Palmdale Hybrid Power PROJECT

Responses to CEC Data Request Set 1 (1-88)

Docket 08-AFC-9

PALMDALE HYBRID POWER PROJECT (08-AFC-09)

Y:\Projects\InlandEnergy\Palmdale\MXD\AFC_Figures\Figure_5-7-5_Farmland_rev2.mxd

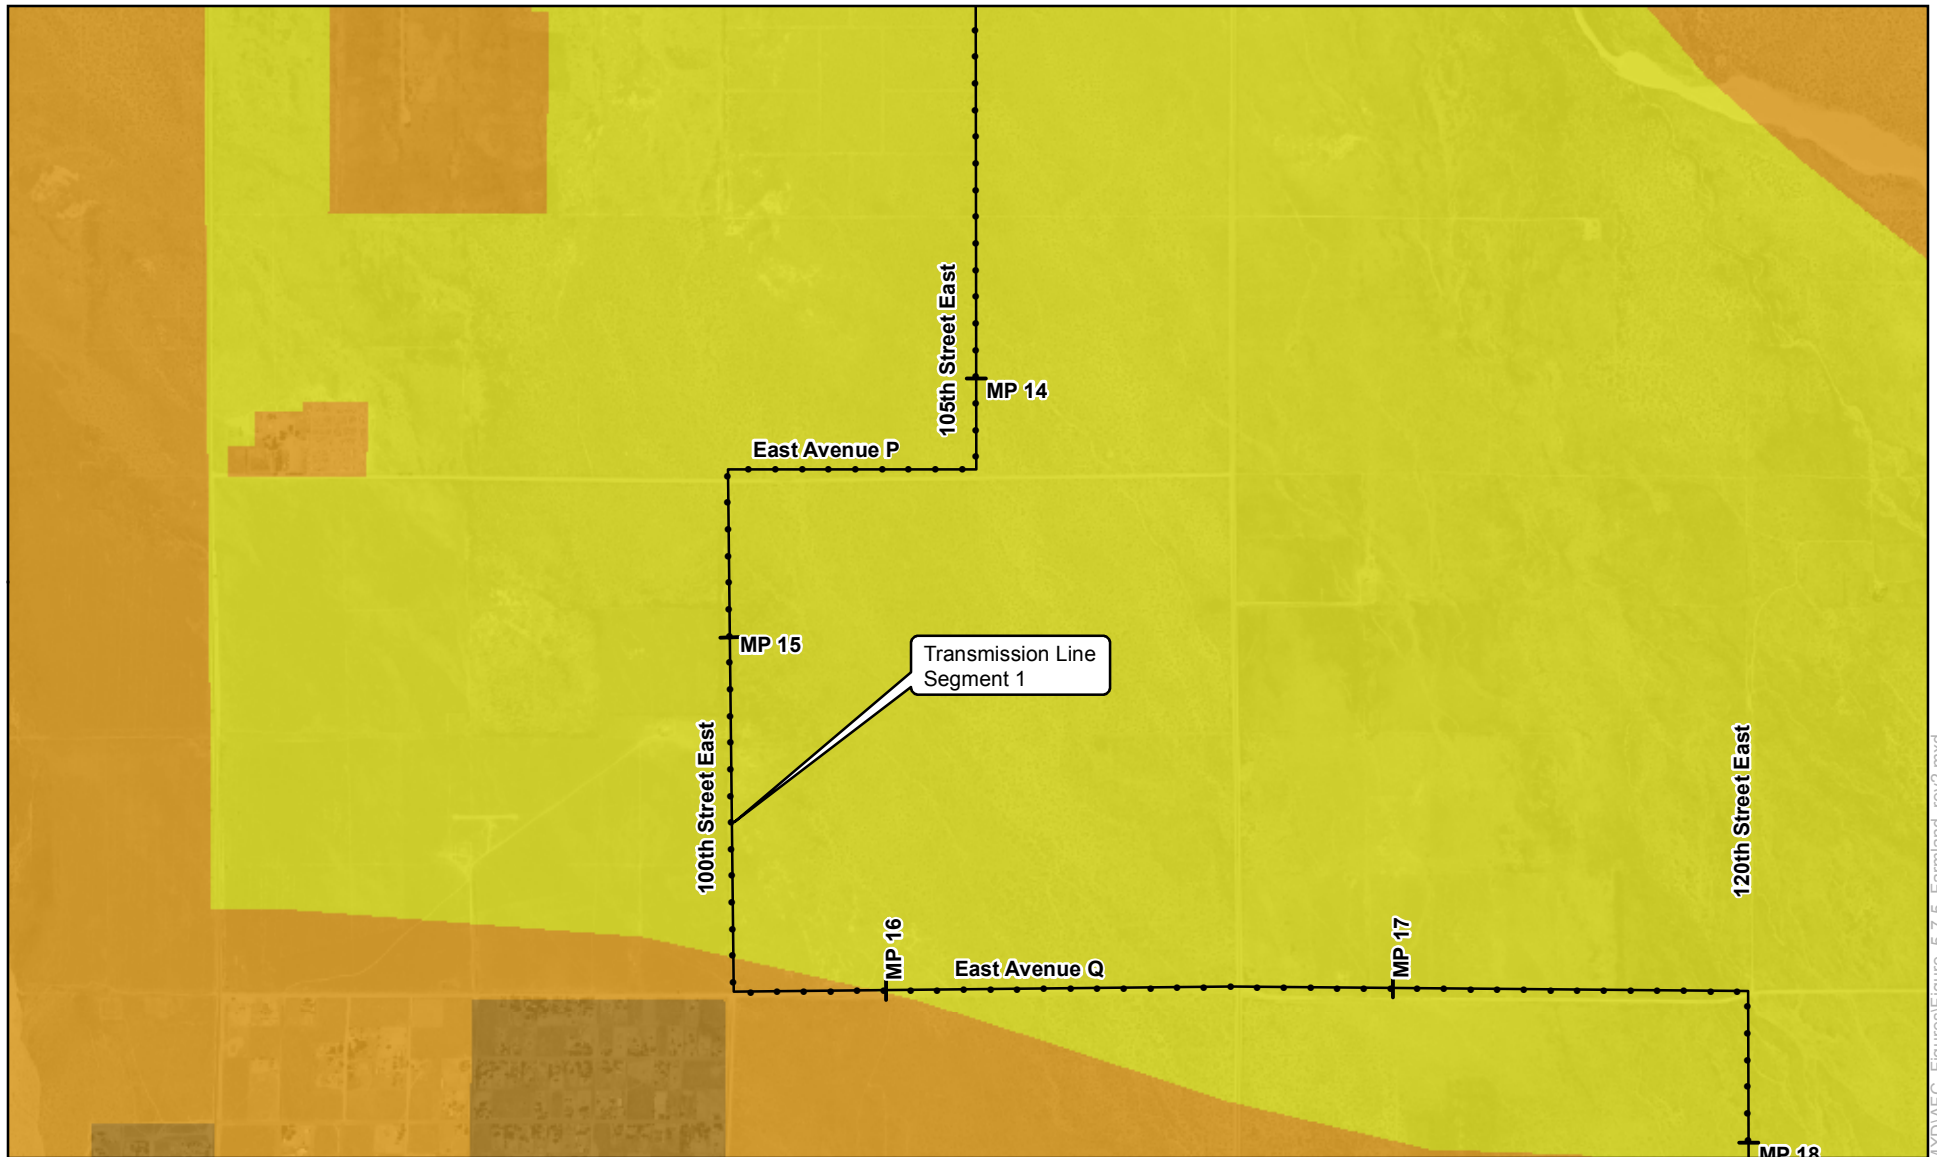
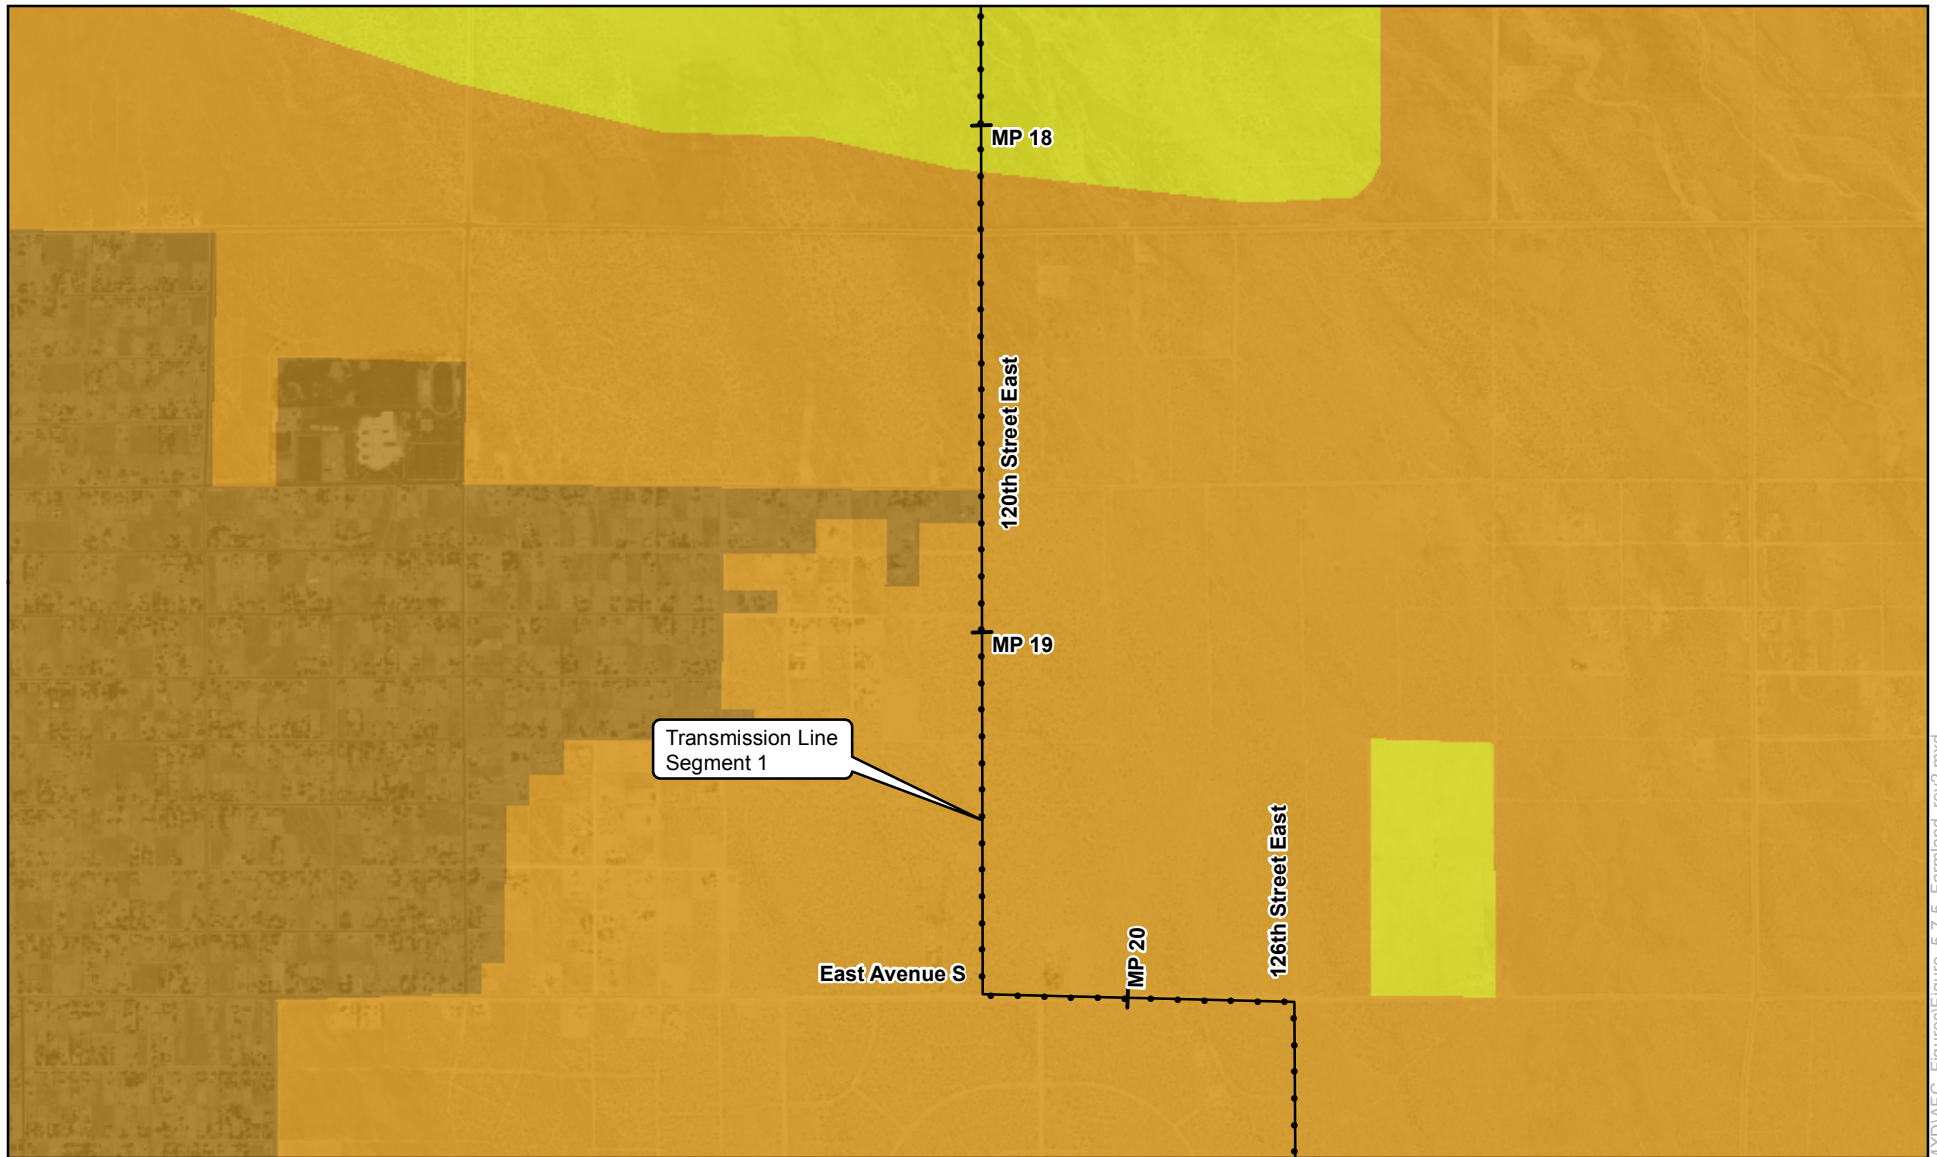
Please provide Figure 5.7-5 at an easily legible scale (e.g., 1 inch = ½ mile).

An updated Figure 5.7-5 is provided at the end of this section in an easily legible scale. The Figure, entitled "Important Farmland in the Vicinity of the Project and Linear Facilities" has been expanded to include 14 discrete mapsheets, each at 1:24,000 scale or one inch equals 2,000 feet.

Attachment DR 80
Conceptual Site Layout

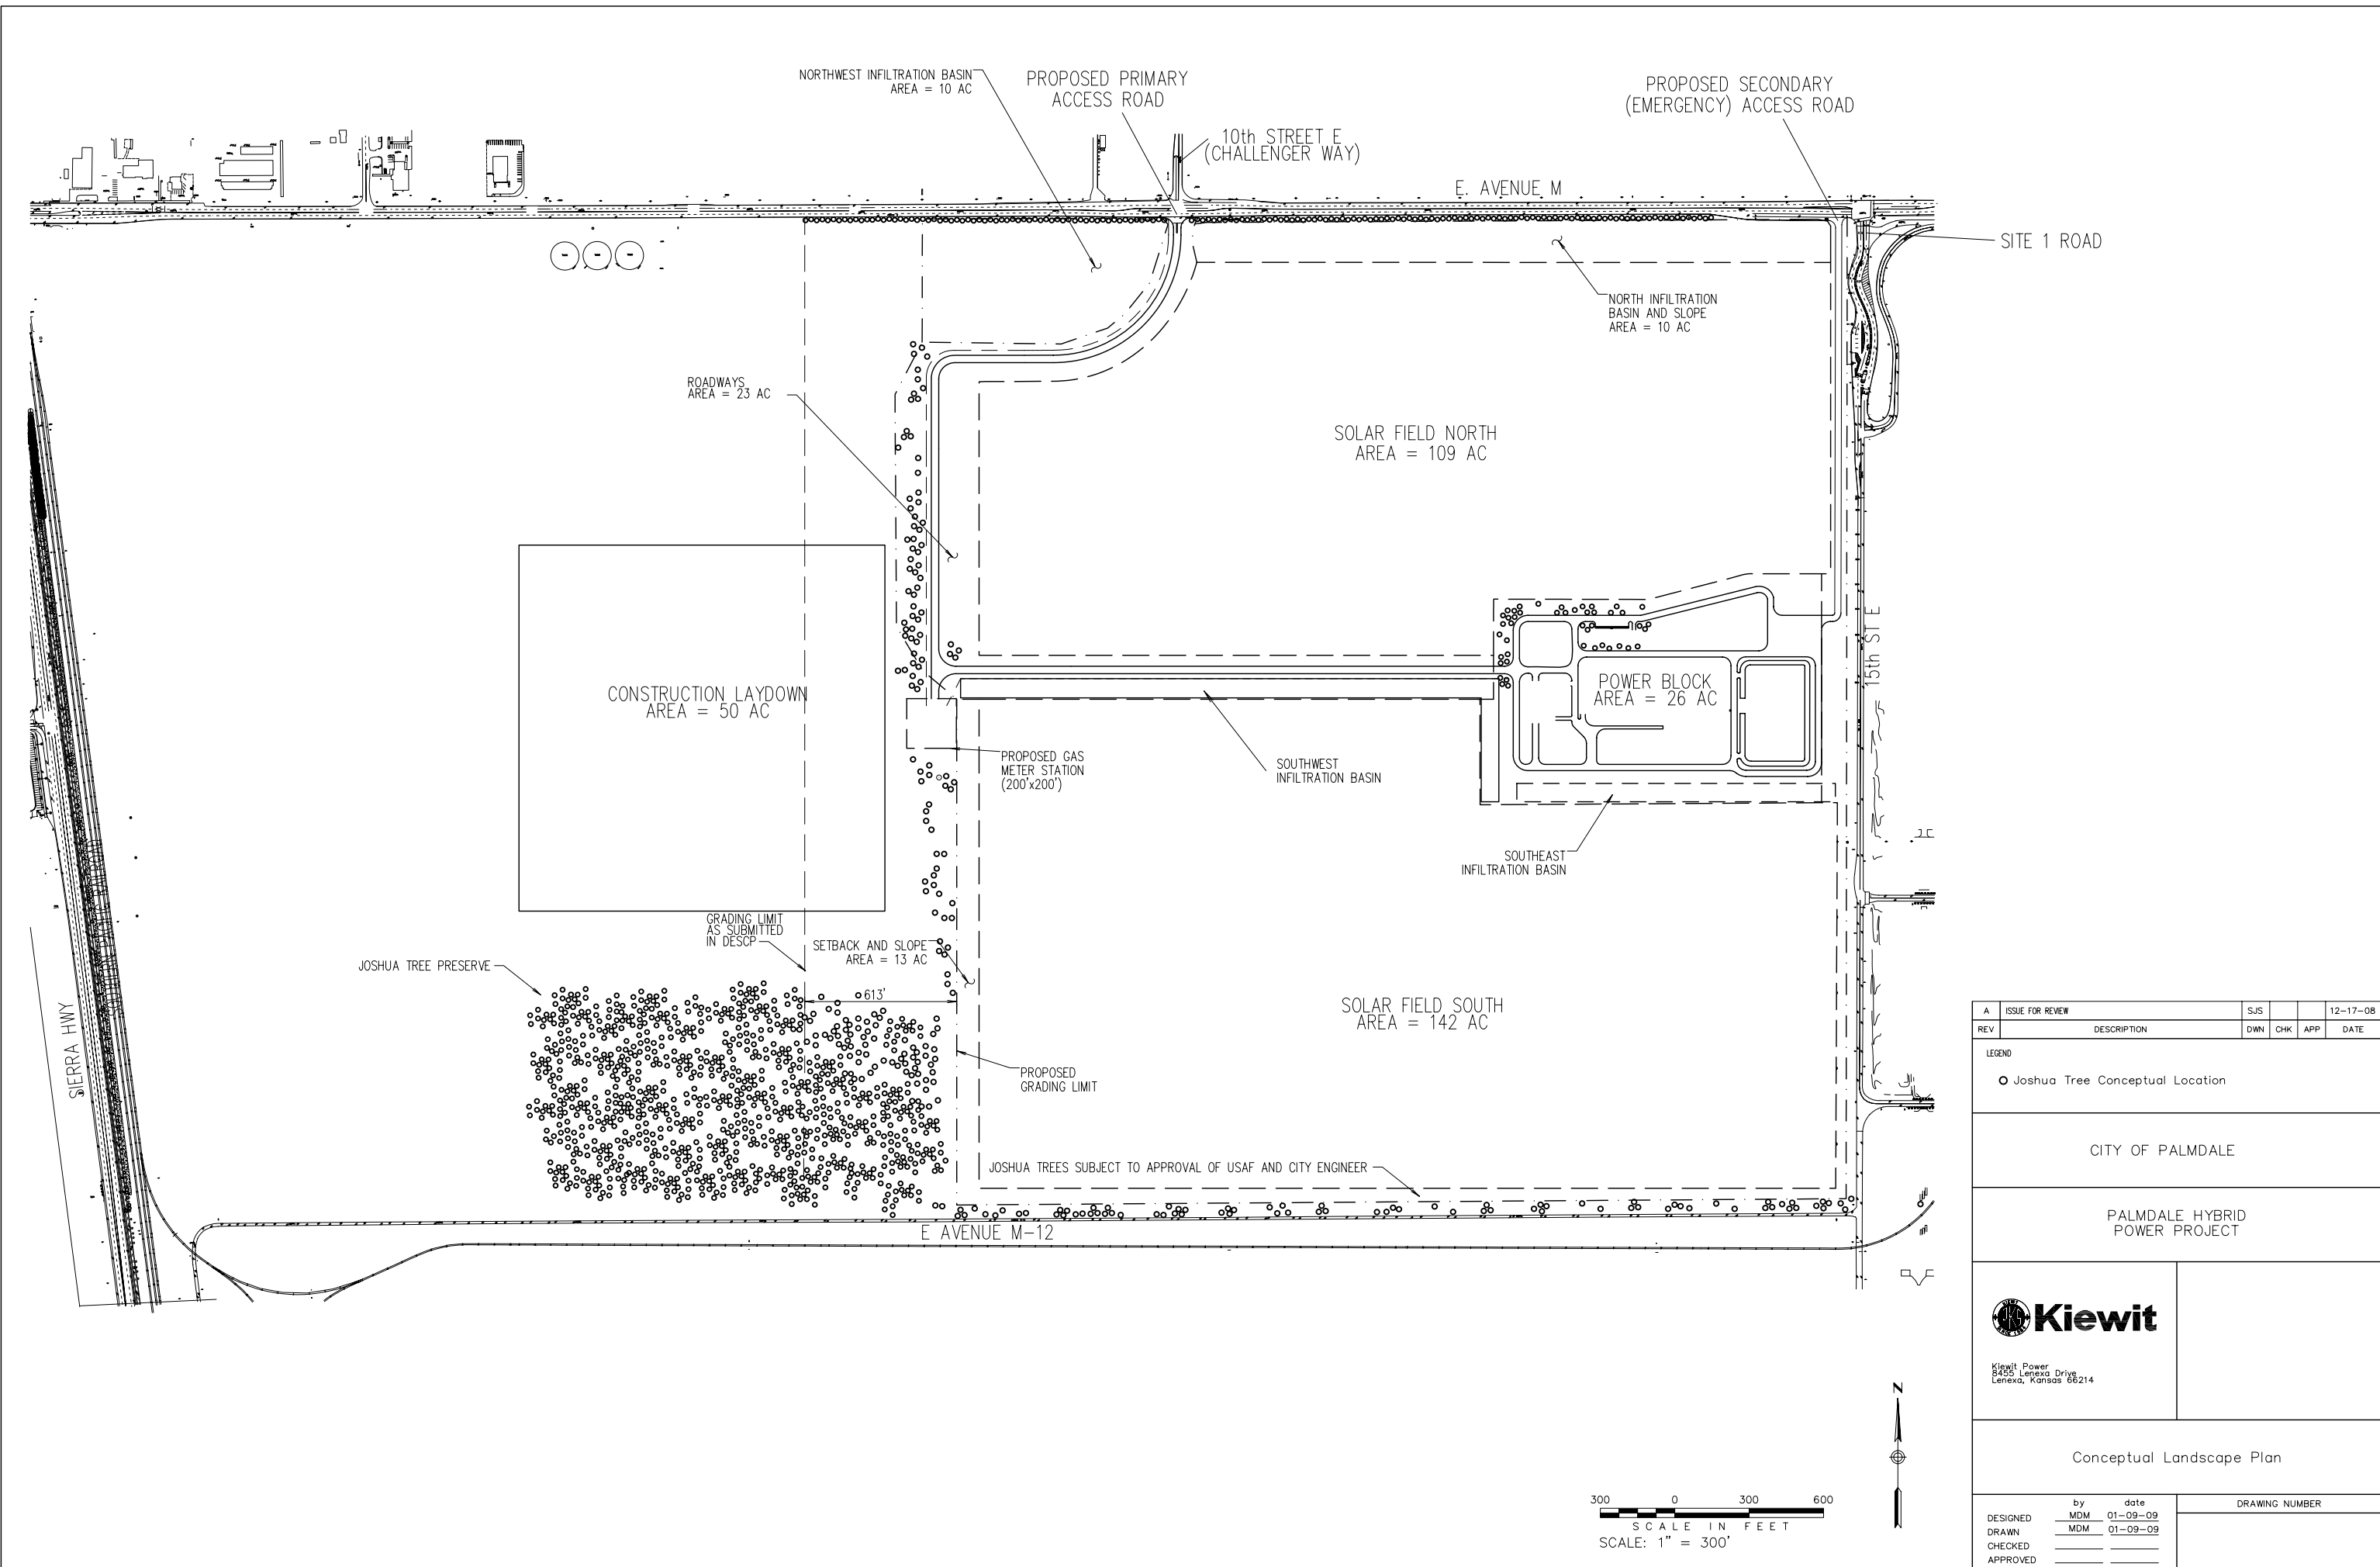
Please provide the Conceptual Landscaping Plan (Figure 5.15-10) on 11-inch by 17"-inch paper.

The Conceptual Landscaping Plan of Figure 5.15-10 in the specified size is provided as Attachment DR-80 at the end of this section. In addition to making this figure larger, other updates, such as the latest site plan showing access roads and Joshua tree relocations, have been incorporated. These updates were discussed and coordinated with the City of Palmdale.
